COMMENT #40

From: Deirdre McKeel <deirdre.mckeel@gmail.com>
Sent: Sunday, January 18, 2015 11:31 AM
To: Allison Satter
Subject: District 2 Final Plan - unpublished Letter to the Editor

Subject: 2016 Comprehensive Plan Update

Re: Water Quality and loss of infiltration required to develop the former 440 acres know as Port Blakely Joint Planning Area, loss of open space, trails and Heins Lake .

Map 3
Bicycle Issues and Opportunities Diagram

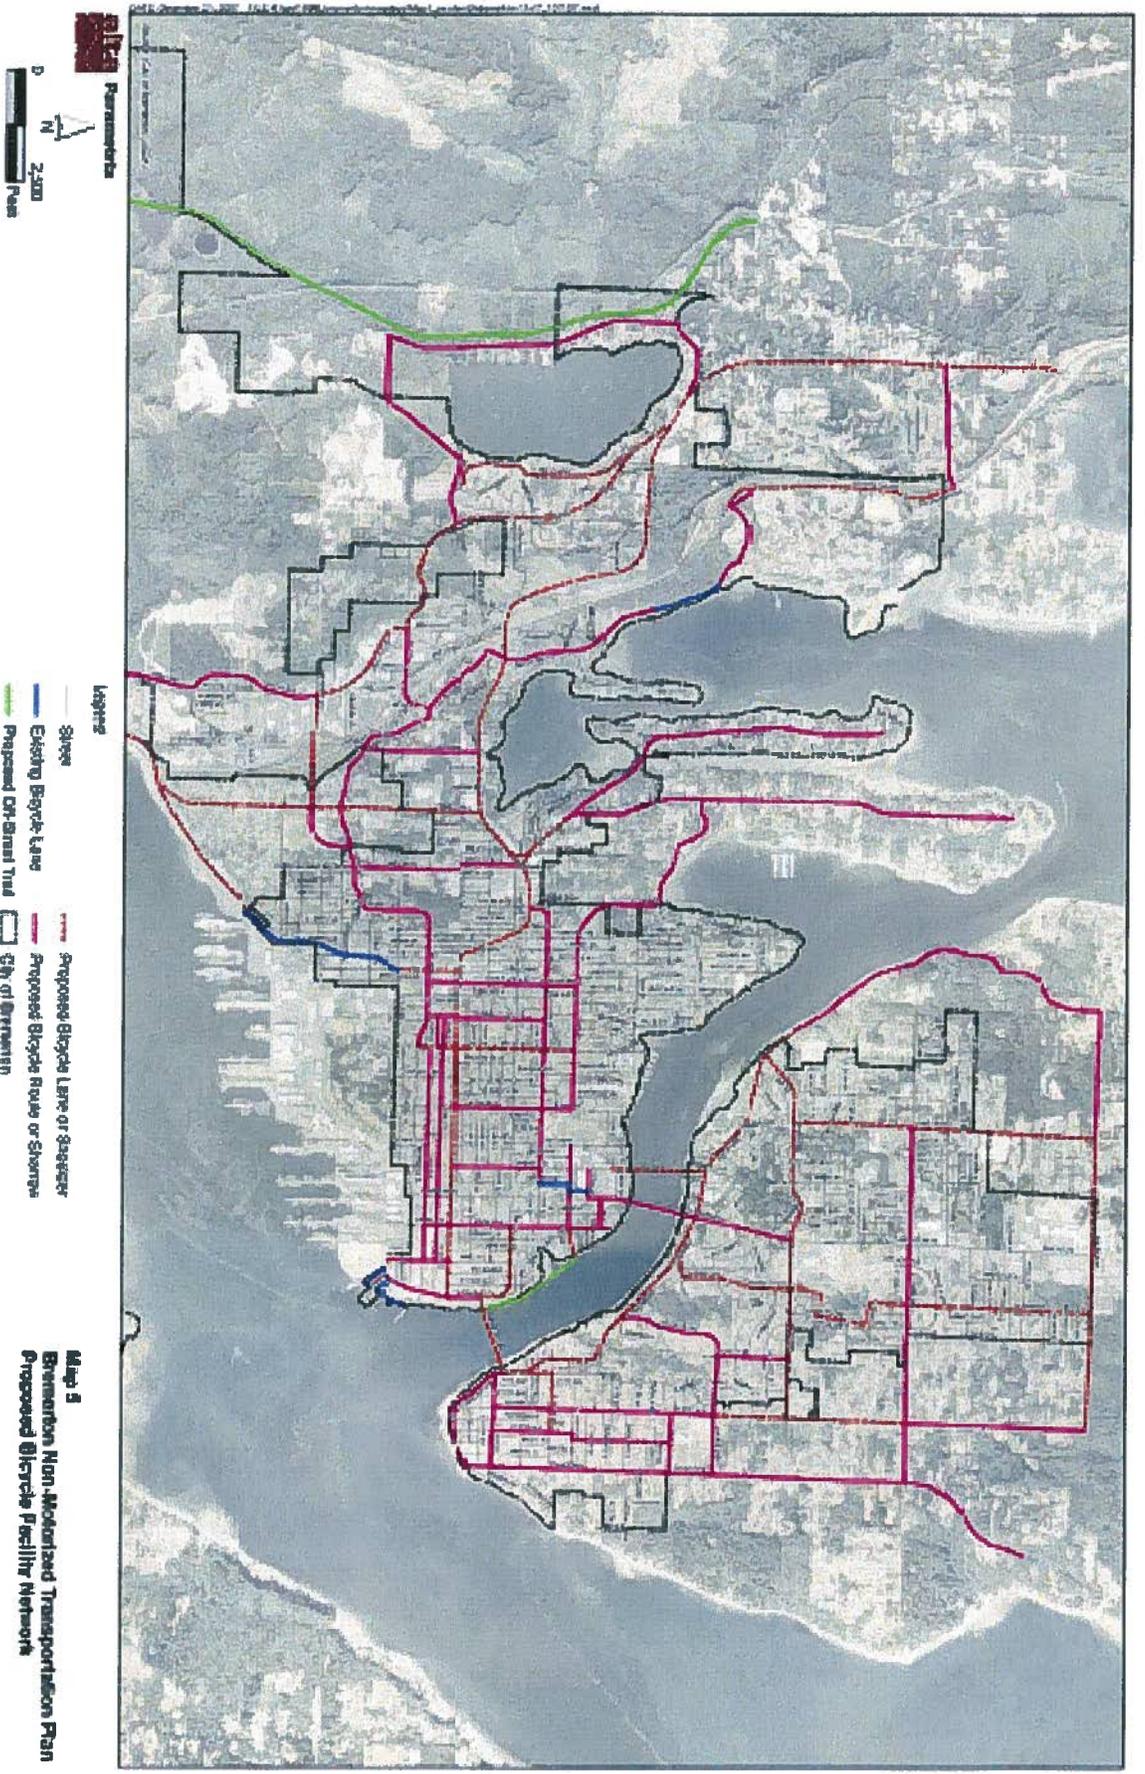
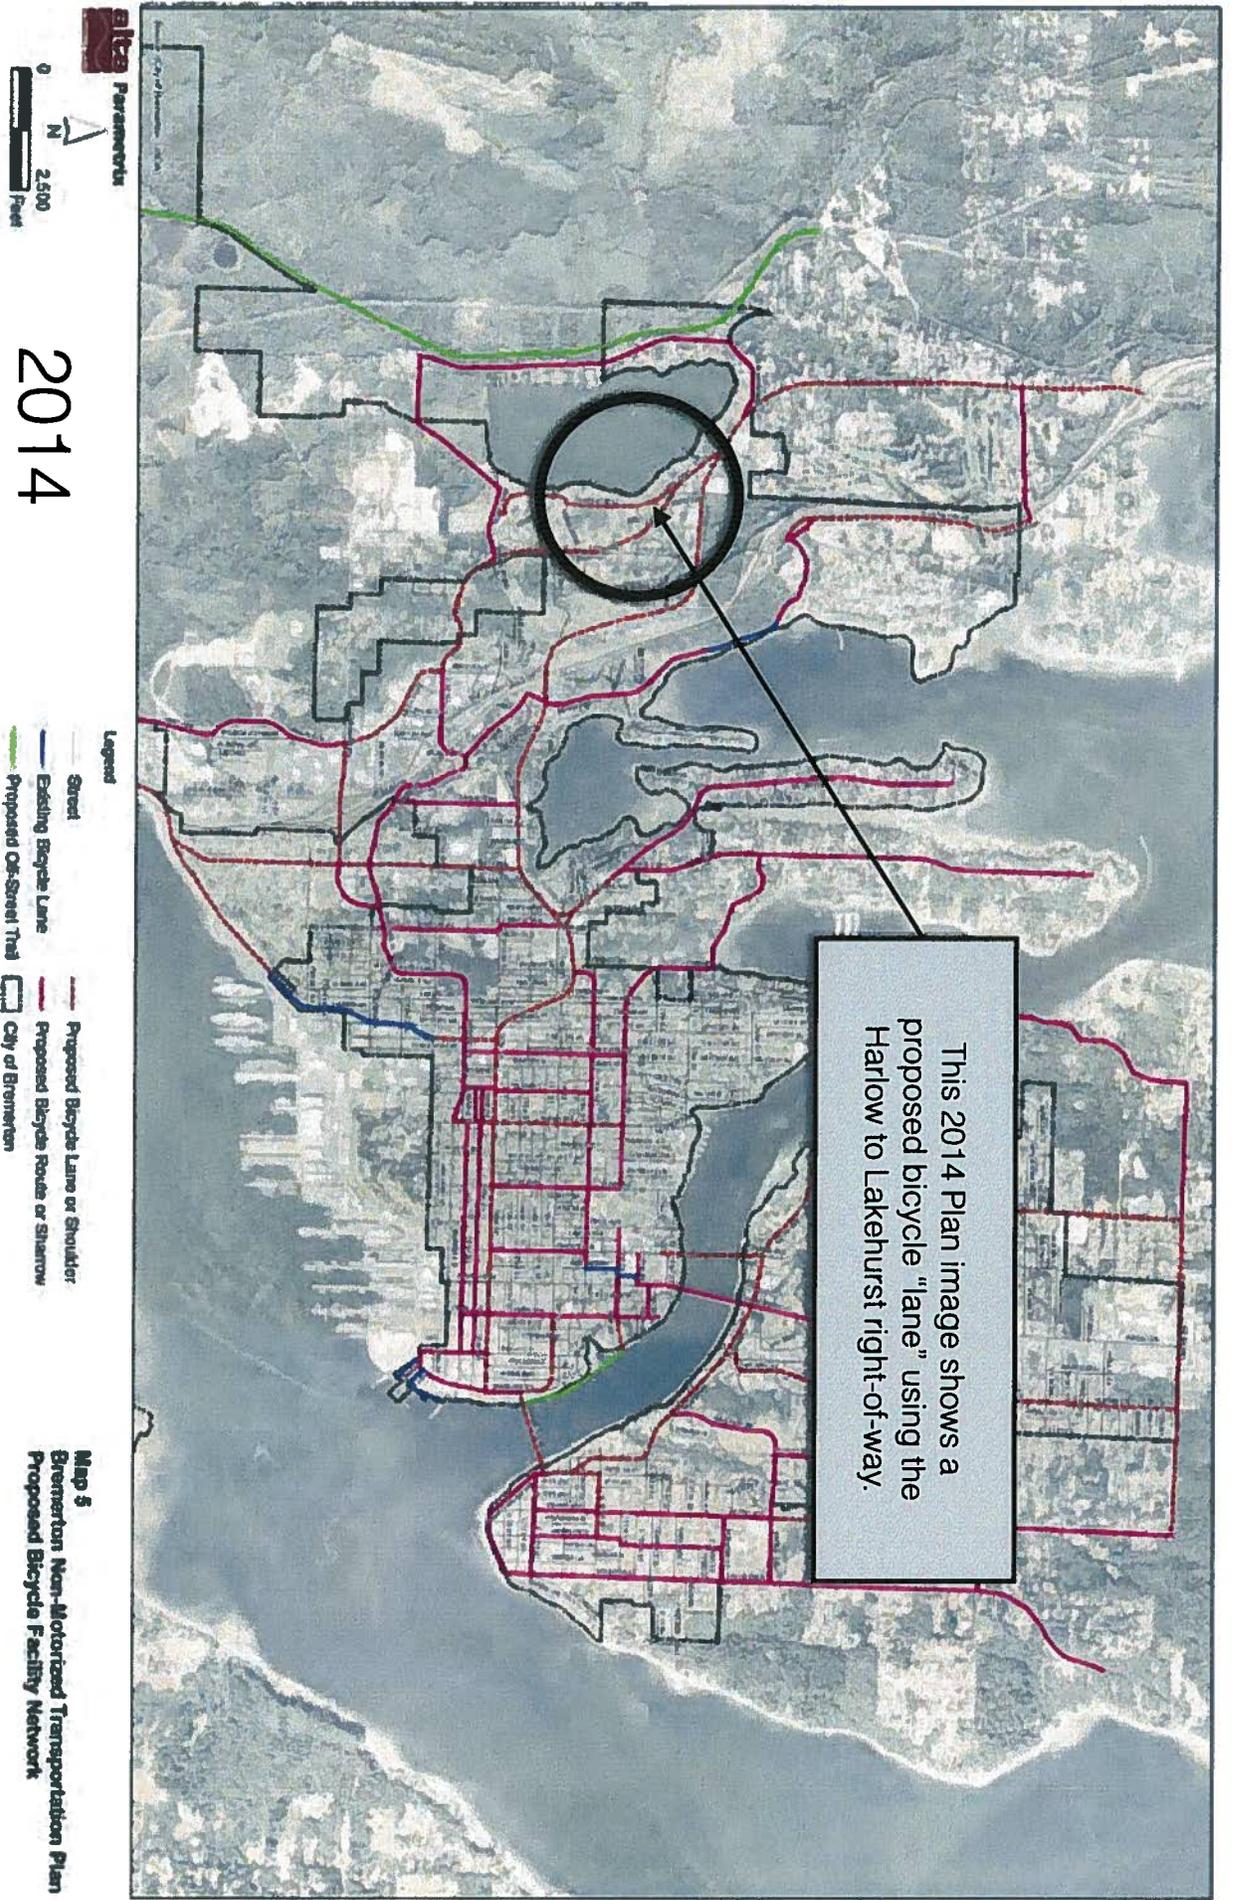
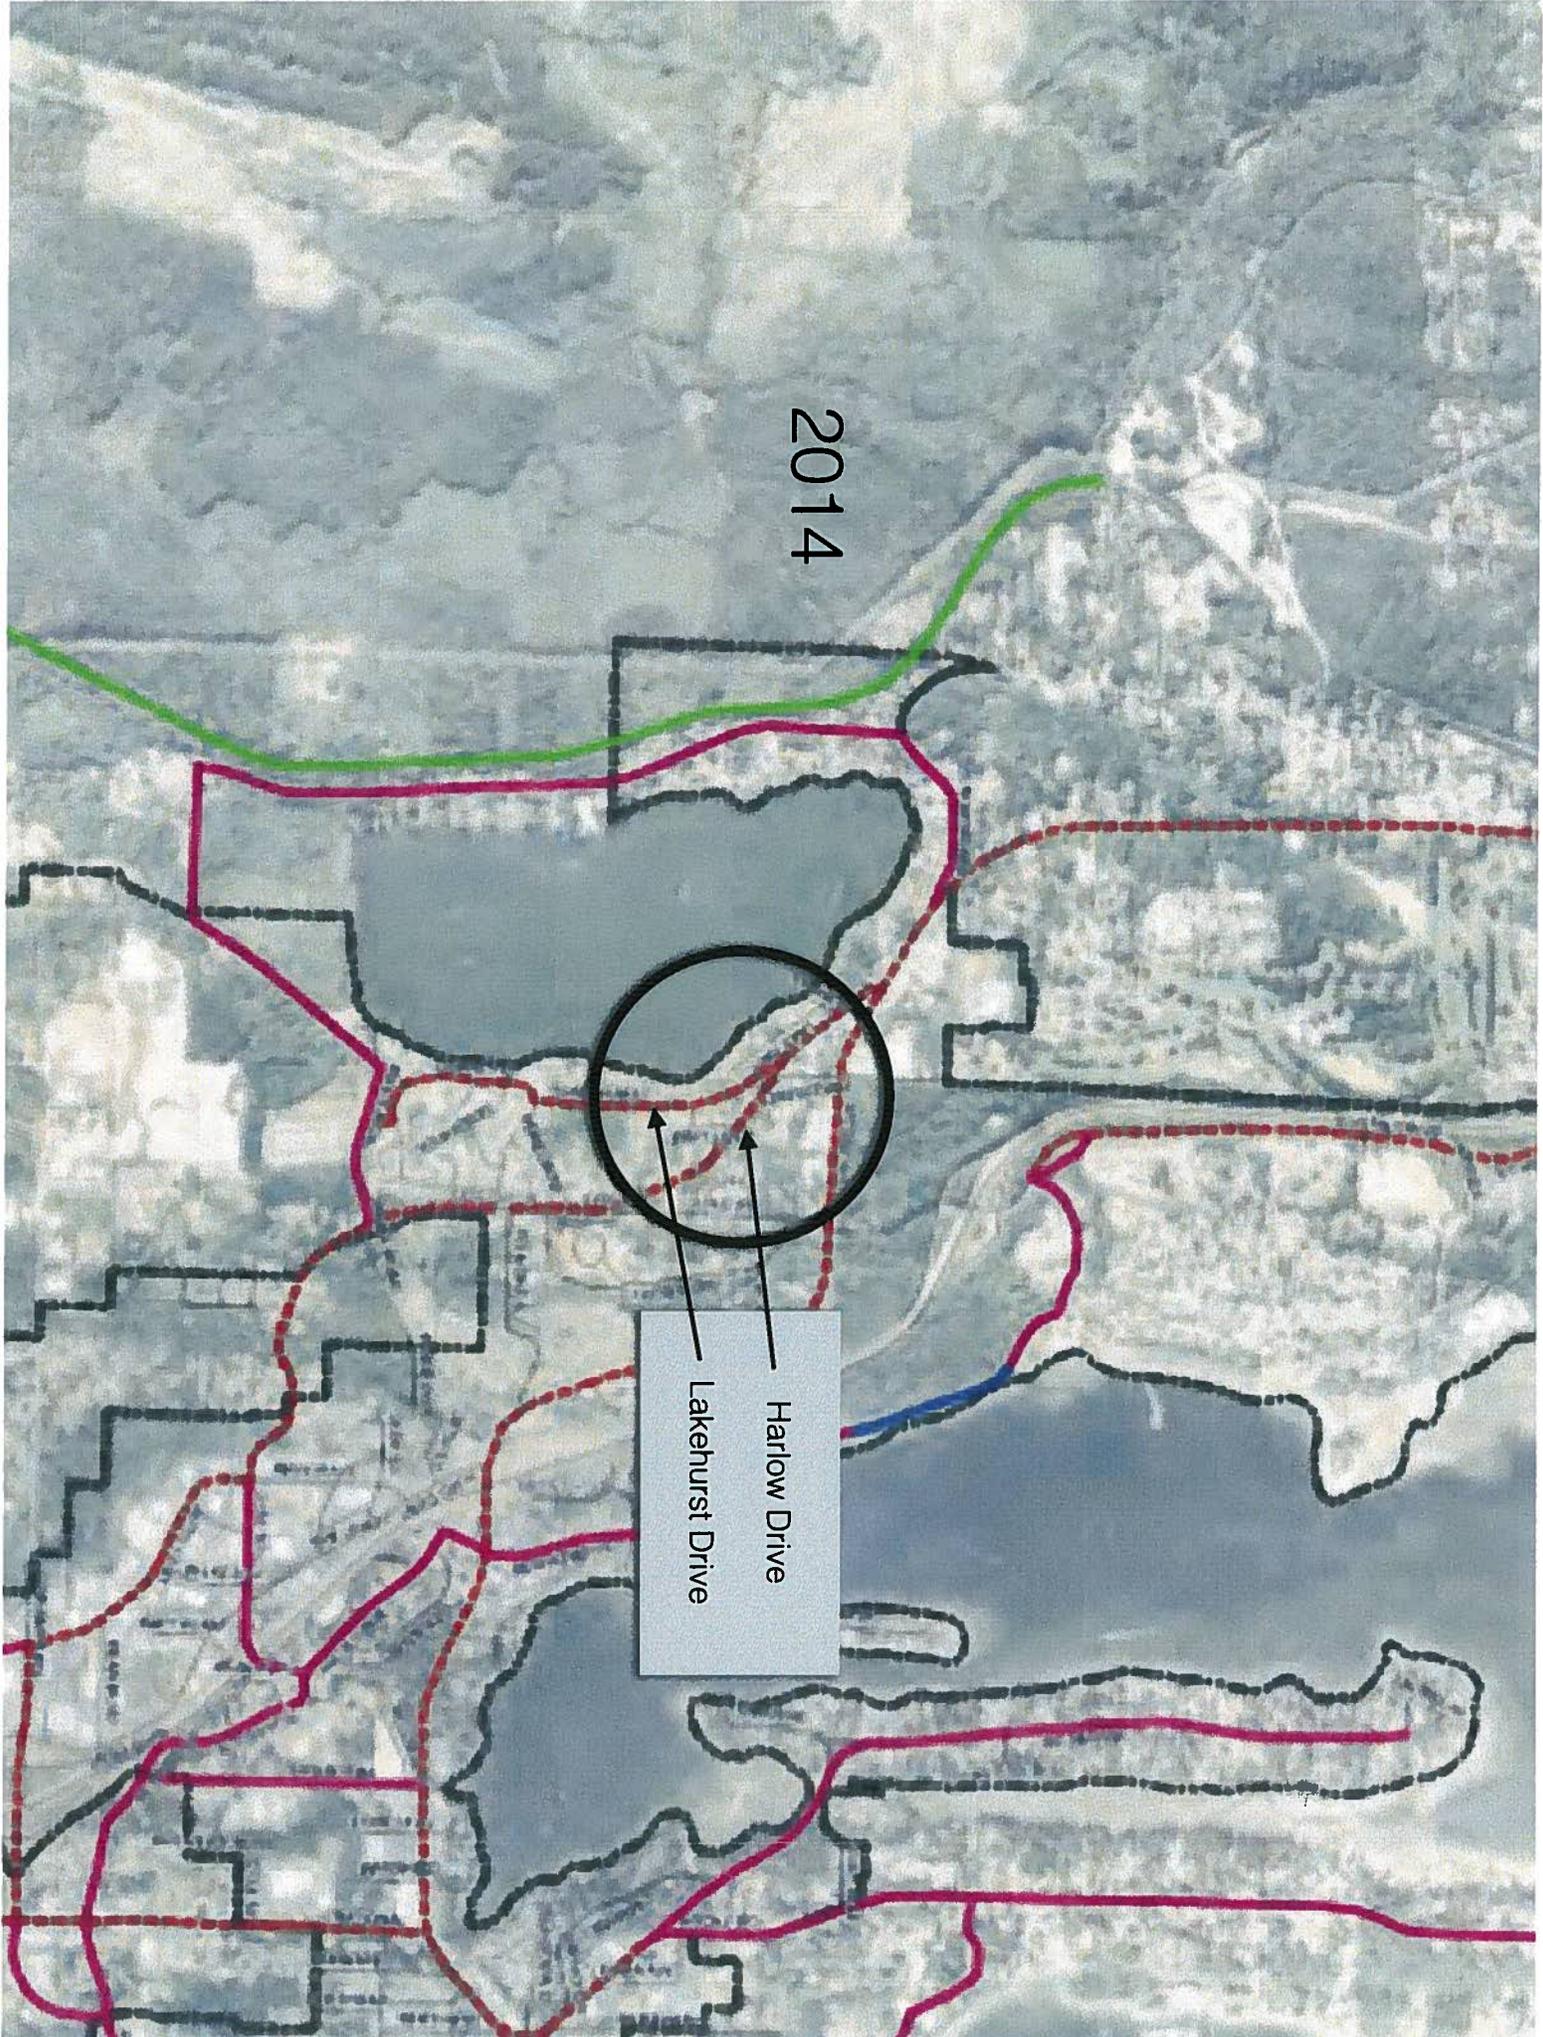
The attached pdf contains screen shots from the 2007 plan and the 2014 plan. Both show a loop trail traversing a public right of way in the northeast end of Kitsap Lake between Harlow Drive and Lakehurst Drive to the south. The last two illustrations, at greater resolution, show the section of trail I would like to have the city create .

This 0.2 mile trail eliminates all hills in the 3.4 mile loop, and would significantly increase its use by cyclists and pedestrians.

Figure 12
Infiltration Potential Map
Port Blakely Planning Area

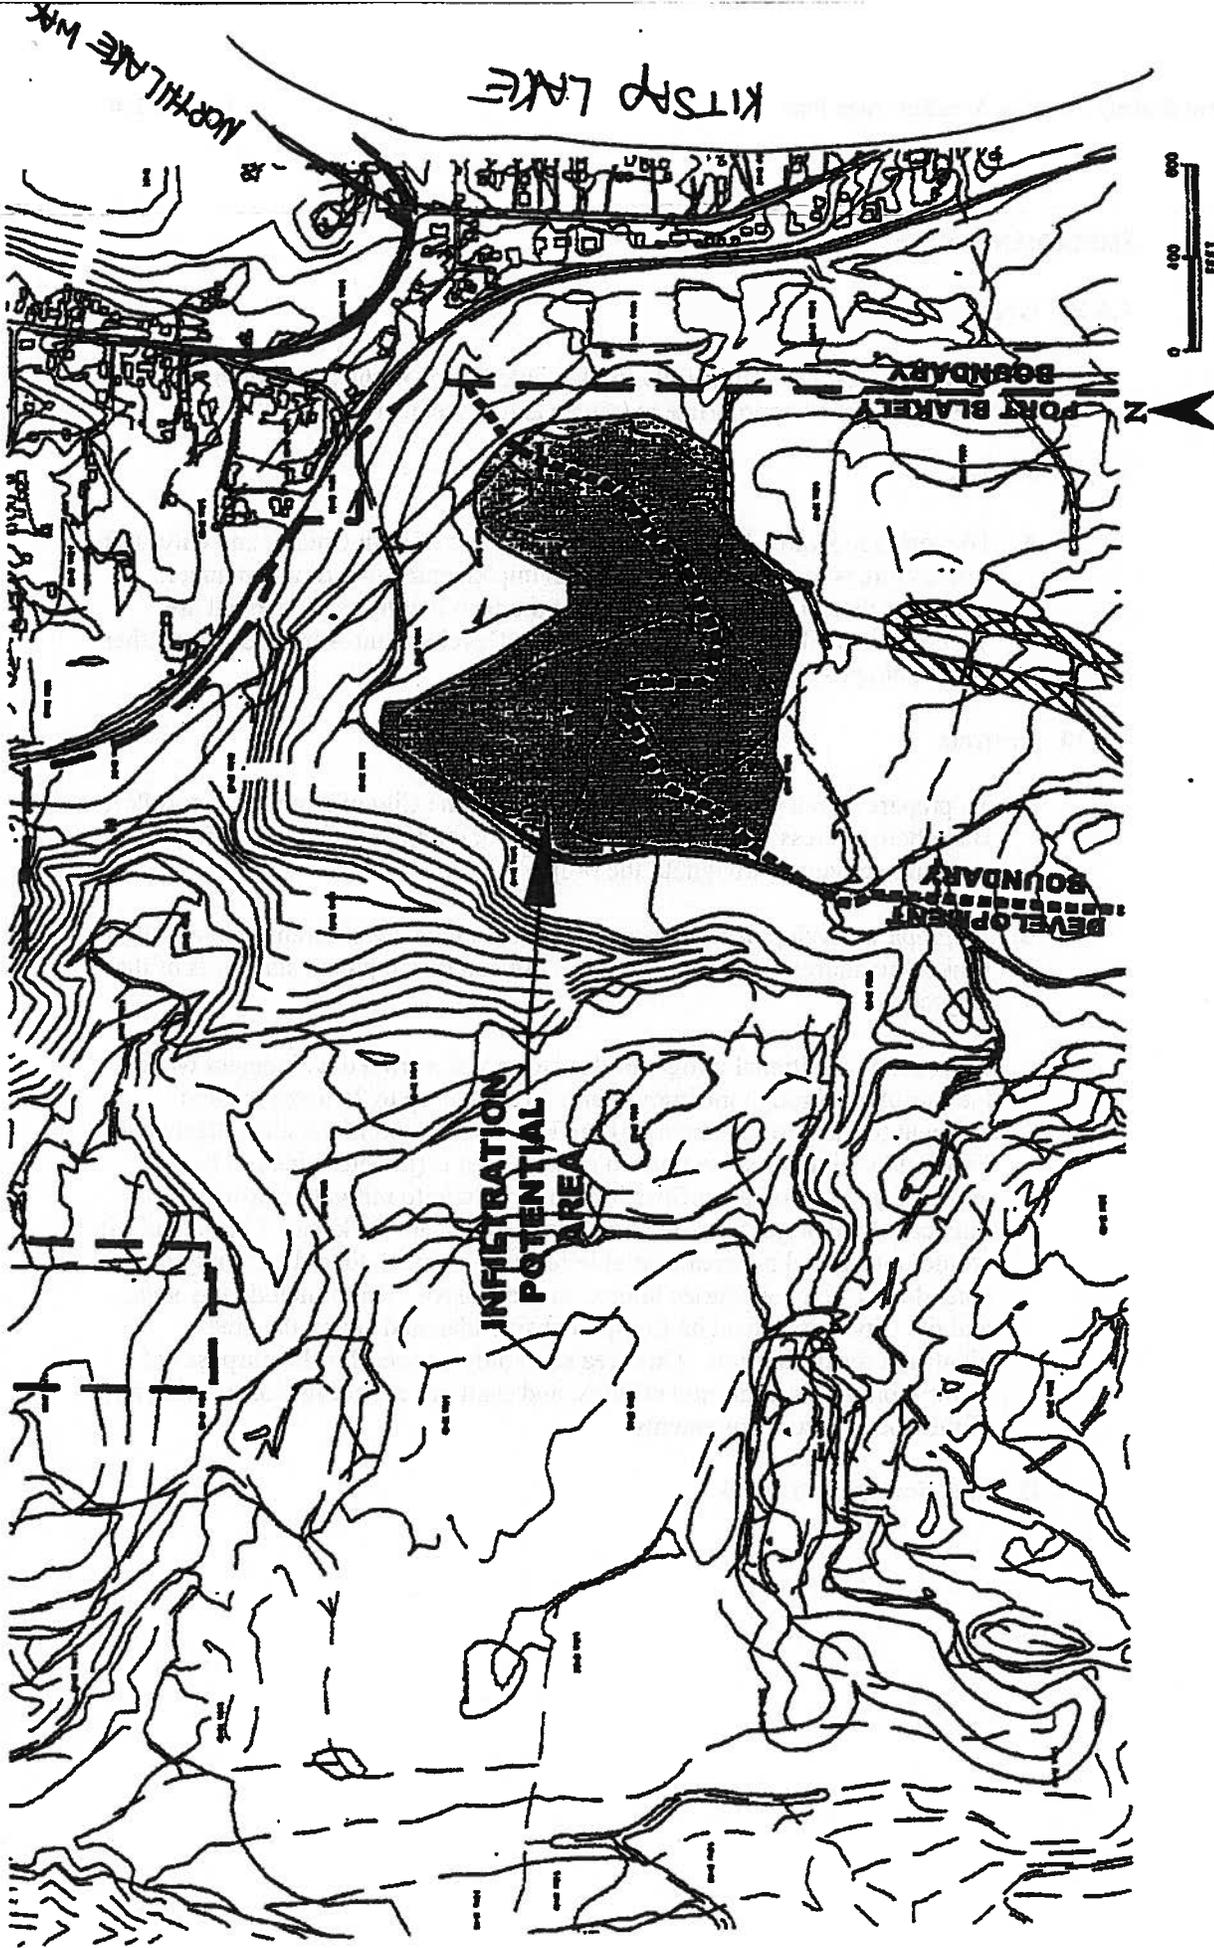
Enclosure 4 - Figure 12 Infiltration Map and page 64 of Version 2.4 explains the importance of the 25 acres of sand and gravel for infiltration.

Inset 1. First mention of Wetland 4, sketch included with 9/30/2010 email. The roads show the location of this W4 is actually the blind north end of Wetland 6. North is to the left of the page.

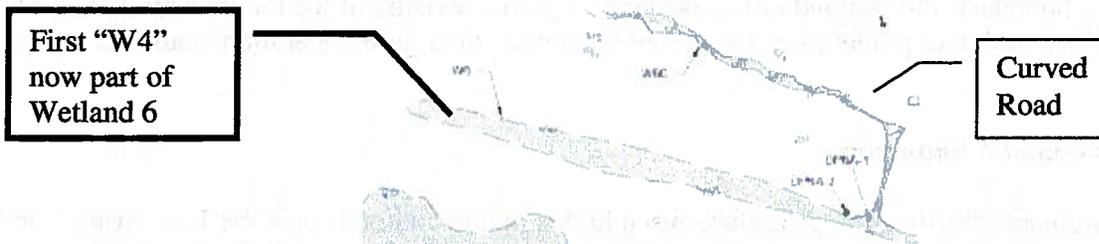
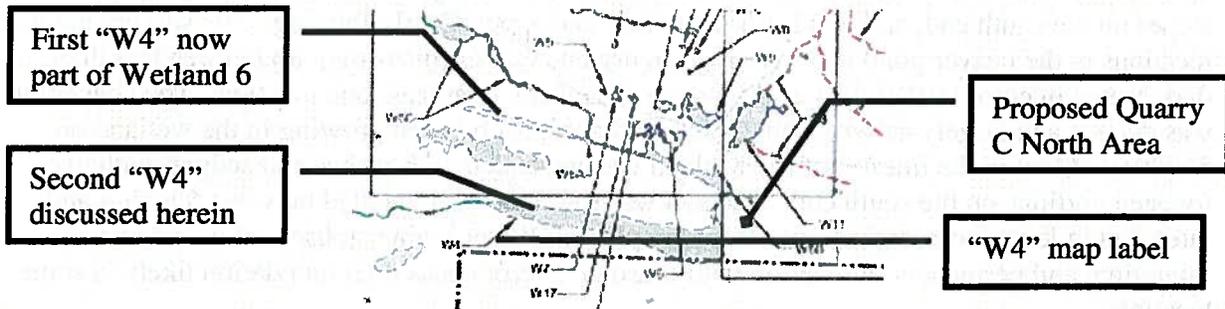
The sketch shows a polygon called 'wetland 4' as the north arm of Wetland 6 (Inset 1). This First Wetland 4 has been incorporated with the rest of the Wetland 6 complex.

The second mention of a Wetland 4 is in the Wetland Delineation Report, which clearly has a wetland labeled “W4” with an arrow pointing to the beaver pond formed in Dickerson Creek. This second wetland called Wetland 4 (“W4”) is not the one incorporated into Wetland 6 as described in the 9/30/2010 email. This second Wetland 4 is the subject of this memorandum.
